**ADDRESS: 1322 PINE ST**

Proposal: Replace door

Review Requested: Final Approval

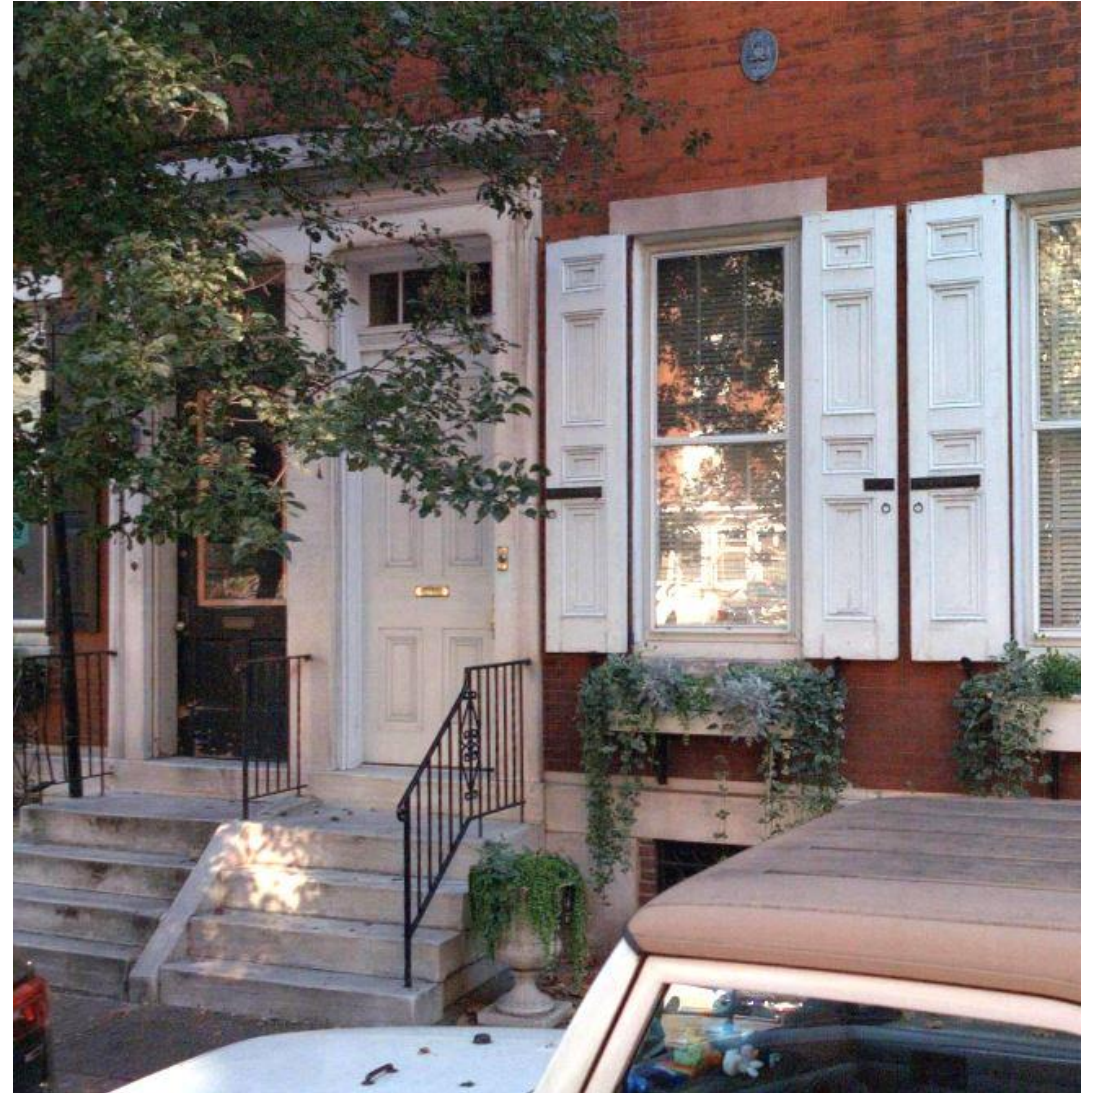
I've included a picture of my preferred door. See below. My plan is to have the door handcrafted from mahogany by Tague Lumber. The door that I am proposing would fill the entire door opening. (I would not build-down to accommodate a smaller door.) The profile of the door would match the shutters on the windows. Nor would I change the existing door jamb or alter the windows. I would only change the door.

If approved, I would ask Tague Lumber to recreate the blue door below in mahogany. The door on the right is an example of a mahogany door from their showroom.

**STAFF RECOMMENDATION:** The staff recommends denial of the proposed door replacement, but approval of a door that closely approximates the detailing of the historic door, pursuant to Standards 6 and 9.
